TOGA Central

Response to Submission

TOGA

November 2022

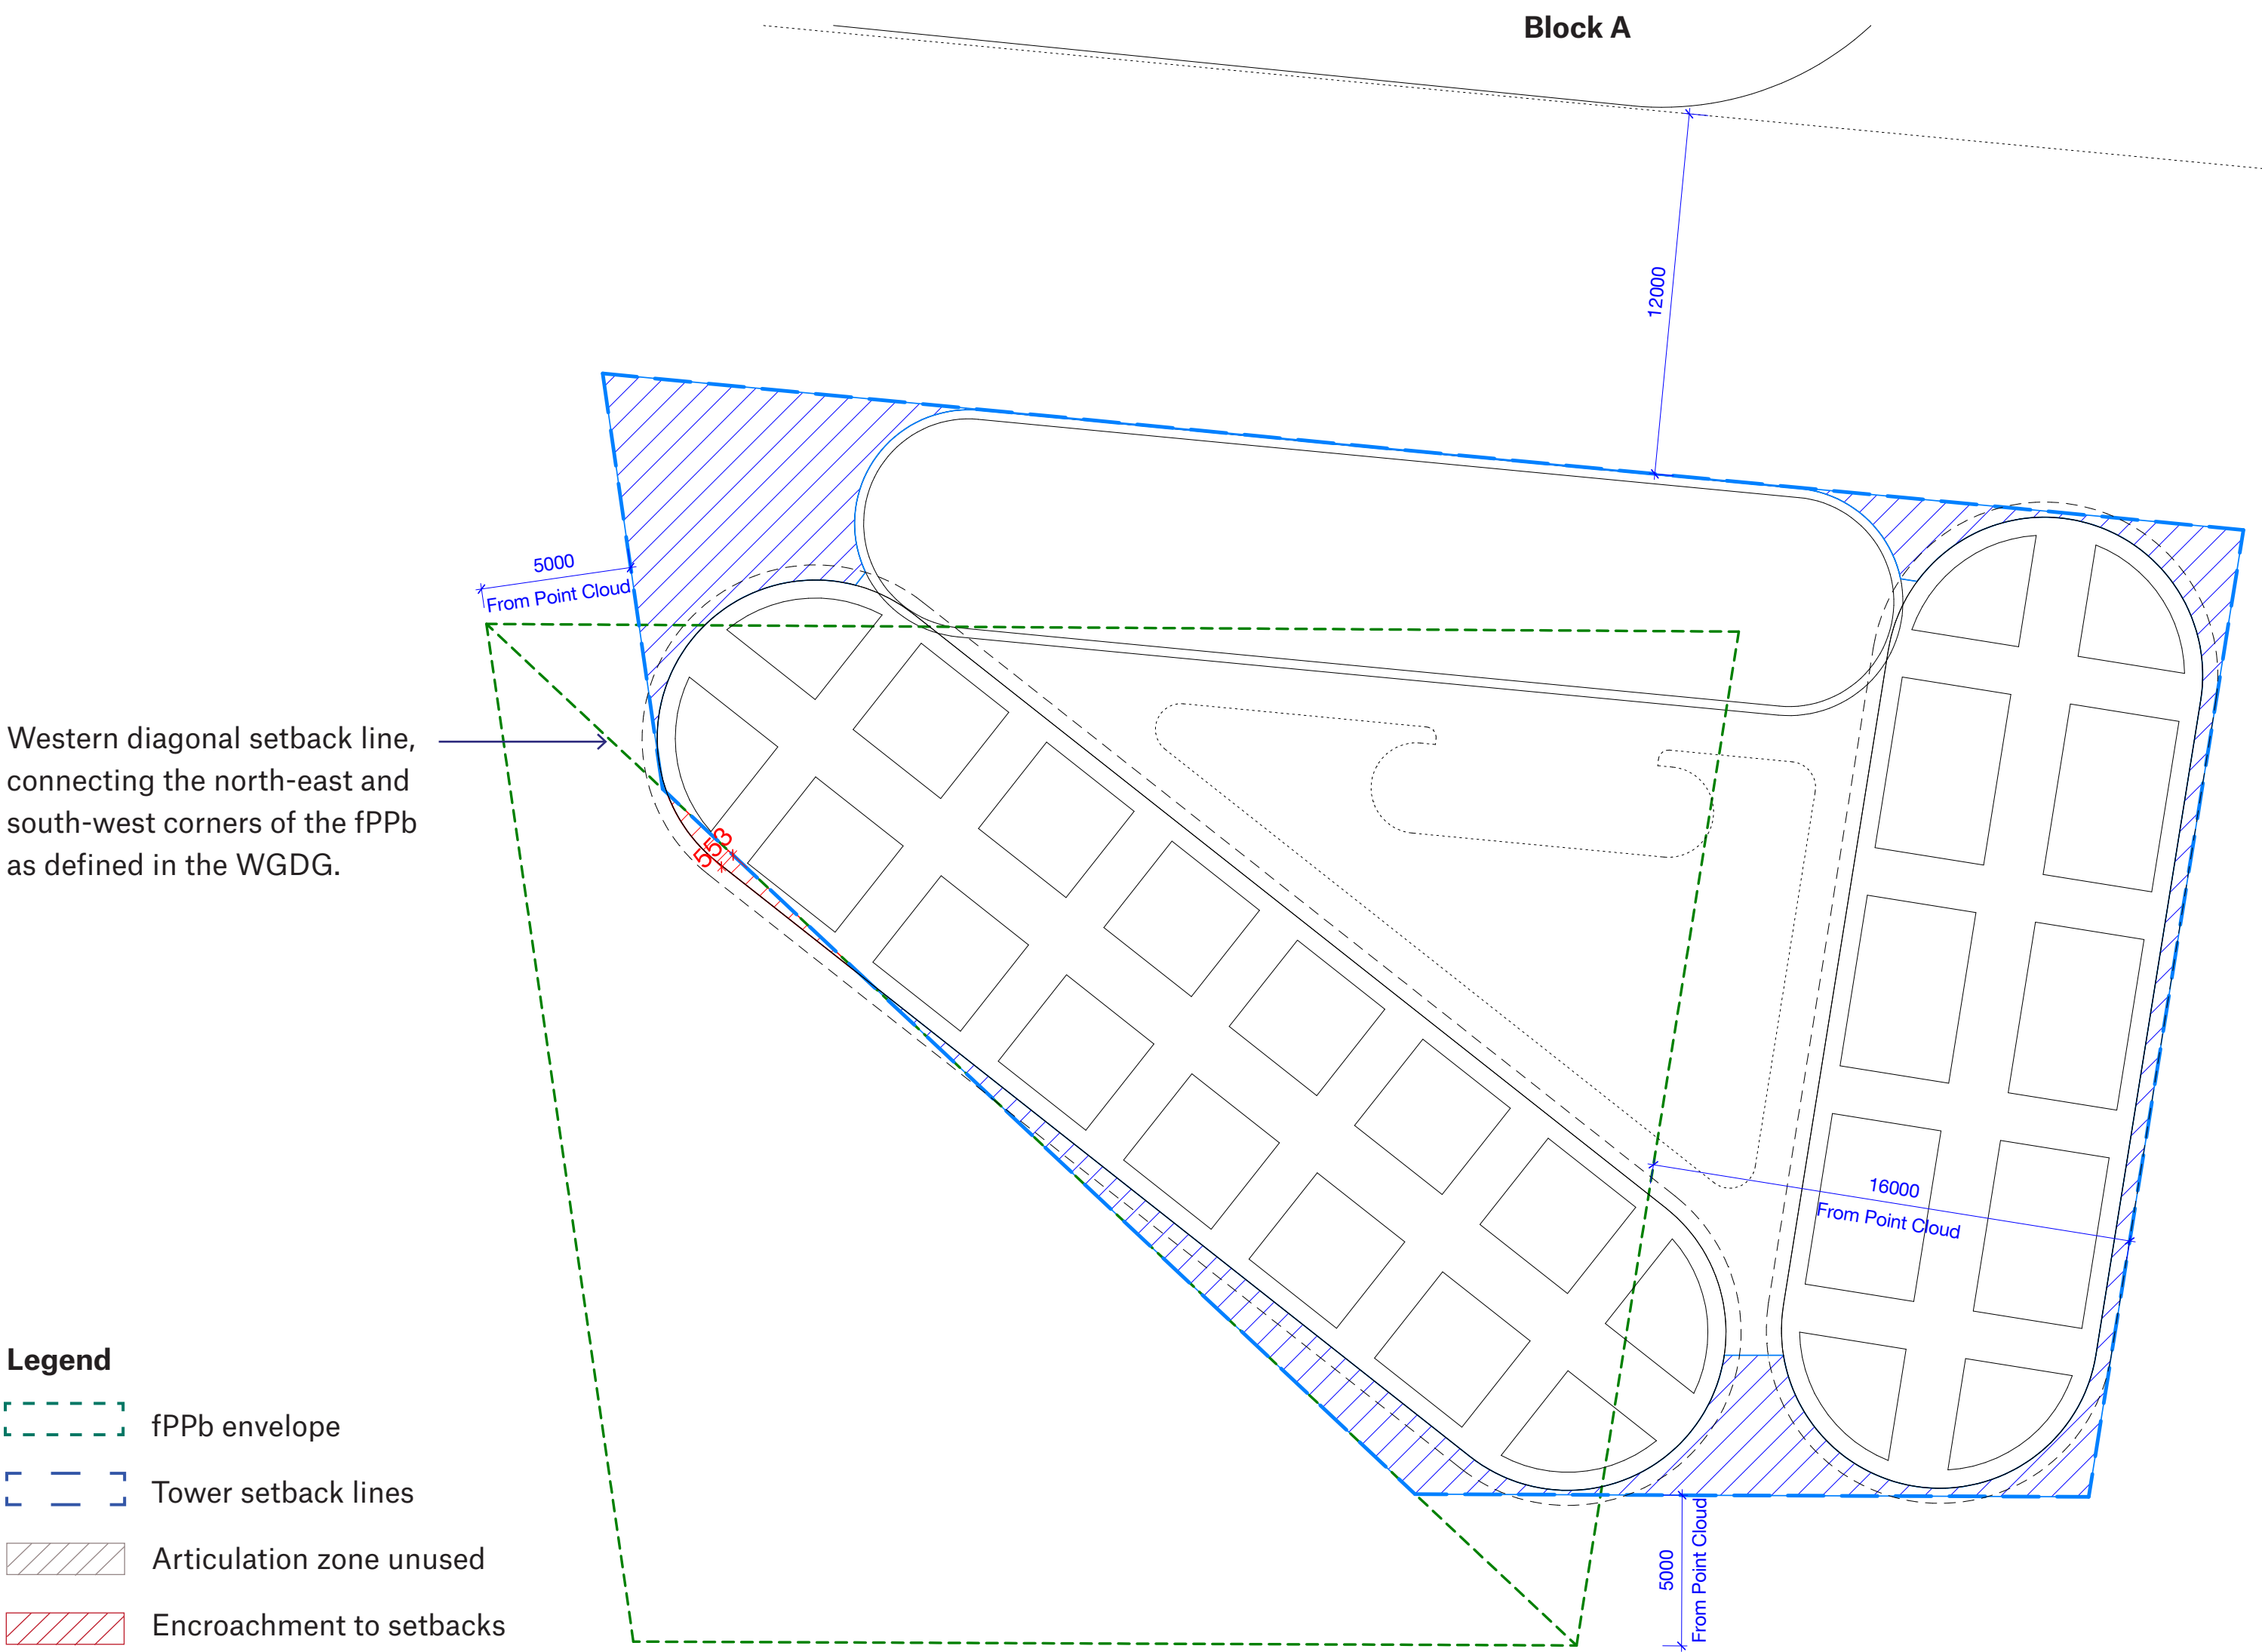
Provide an updated setback compliance plan that demonstrates the setbacks of the proposed building (instead of the building envelope) against the building envelope and setbacks established in the Western Gateway Design Guide and SLEP establish building envelope and minimum setbacks

The proposed design is consistent with the planning provisions contained in the Sydney LEP 2012 and the Western Gateway Design Guide. The expression of 3 distinct pill shaped elements resulted in areas of unused articulation within the envelope (ca 154 sqm), allowing greater views past the north-east corner and a western facade rotated in eastern direction, reducing visual impact from George Street. This led to a slight encroachment (ca 3 sqm) of the western diagonal setback line defined in the WG Design Guide.

To ensure a most accurate setting out of facade lines, all setback dimensions are based on a Point Cloud Survey of the fPPb. The site boundary has been omitted from the adjacent diagram for clarity, as this is not relevant to defining the setback lines.

Ground floor plan - revised design

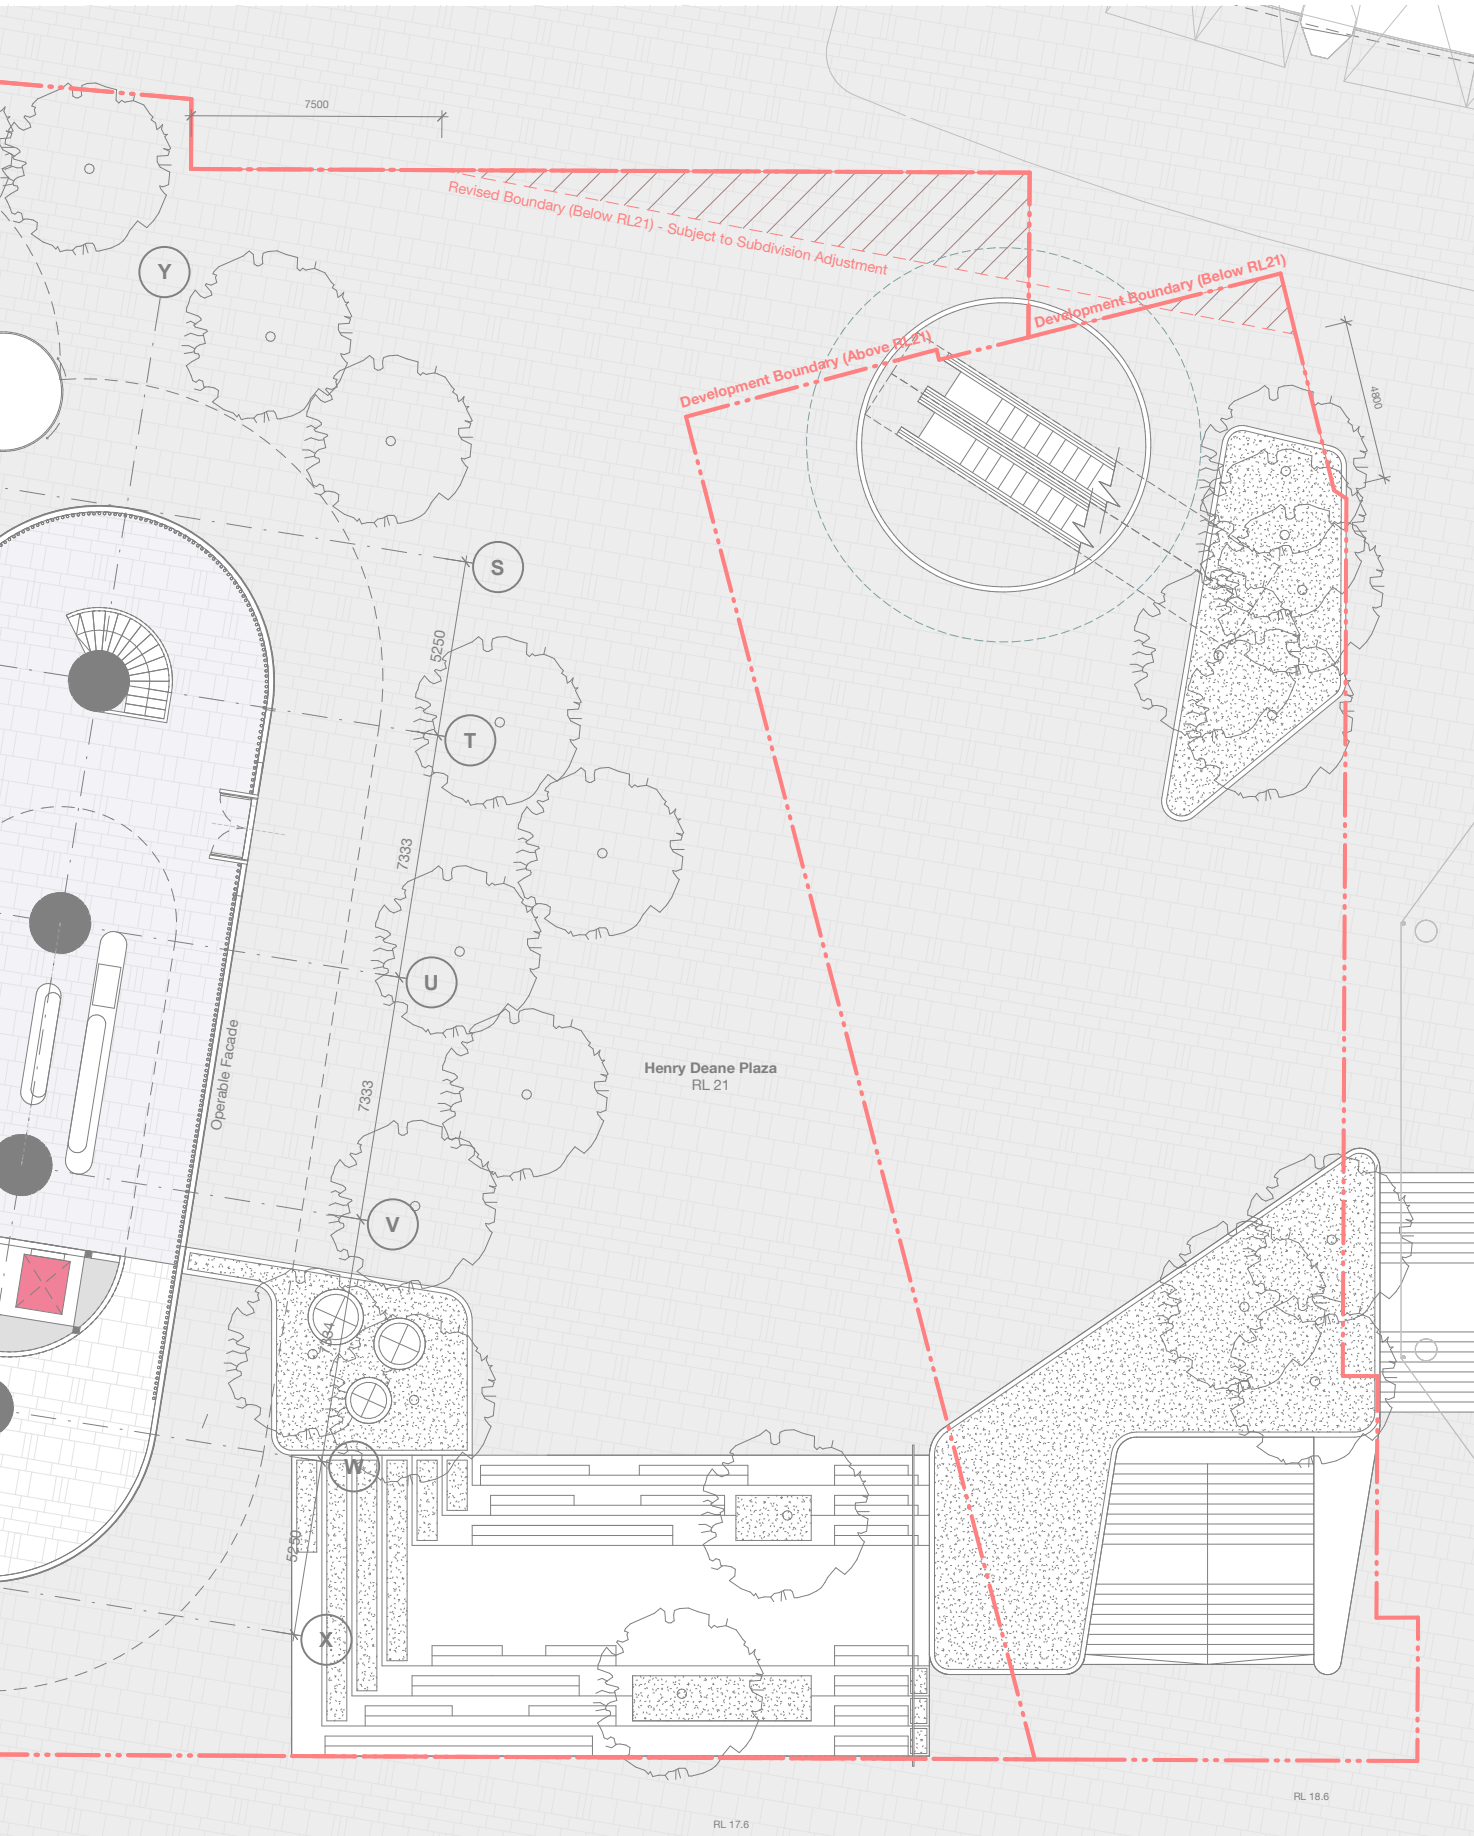
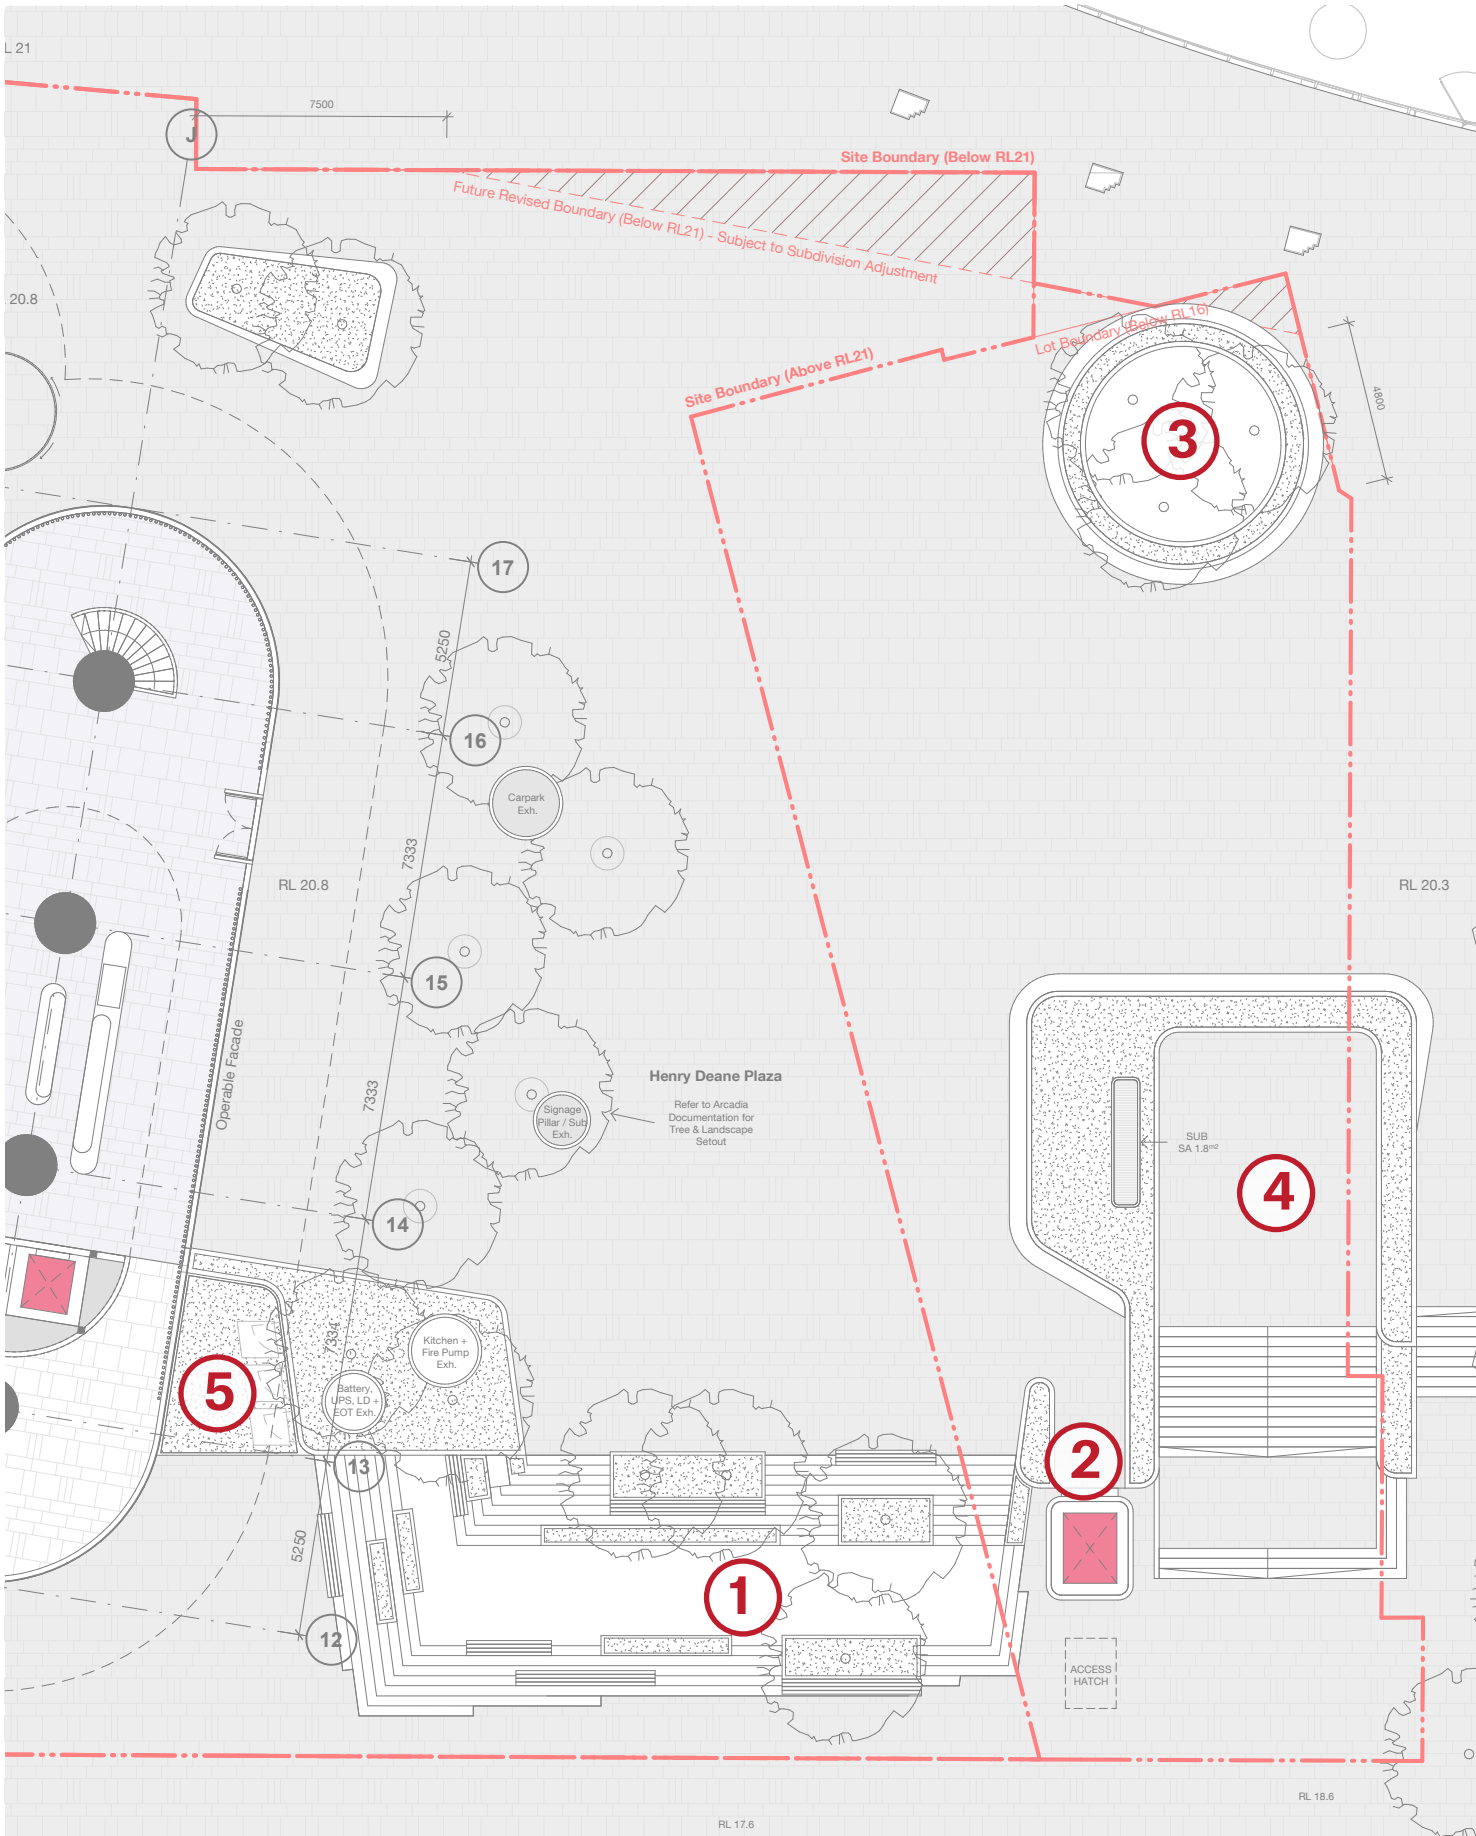
Provide a revised public domain package that provides a comprehensive and integrated design to the CPS site at interim and final stages of the development of the site including:

- a) integrated levels between the design of the upper ground floor public domain treatment within the site and adjoining proposed CPS development
- b) equitable access from Lee Street to the upper and lower ground floor levels
- c) details of materials and finishes that create a consistent design throughout Henry Deane Plaza.
- d) resolution of the proposed dead spaces located between the Henry Deane Plaza stairs fronting Lee Street and the glazed tower atrium and between the eastern and southern 'pill' buildings (Figure 2).

The public domain design has been further advanced since the SSDA submission in July, and coordinated in weekly design meetings with CPS. The following areas have been refined:

- 1 - Levels have been coordinated to link between the developments. As part of this, the main stair leading to the upper deck has been reduced in height by lowering the plaza level and introducing a cross fall towards Lee Street. The stair has also been set back from the property boundary, allowing adequate treatment for handrail extensions and tactile flooring.
- 2 - The public lift along Lee Street now also serves the upper plaza level, interconnecting RL 16, Lee Street and RL 20.5. The lift has been sized to allow for 2 bikes or one pram or one wheelchair.
- 3 - The oculus has been opened up, the roof omitted, and the escalators removed. The design language and placement has been coordinated with CPS to ensure a consistency in the public domain design

4 - The stair leading from Lee Street to RL 16 has been opened up to the sky to introduce a laneway character, further enhancing access to daylight sporting intuitive wayfinding and lifting the subterranean feel. Vertical walls have been reduced in height to provide better visibility across Henry Deane Plaza and visual access to key building entries at RL21 level as well as from Lee Street.

5 - The recess between the southern pill and planter has been developed to now include a planter, linking the upper and lower planter into a common expression.
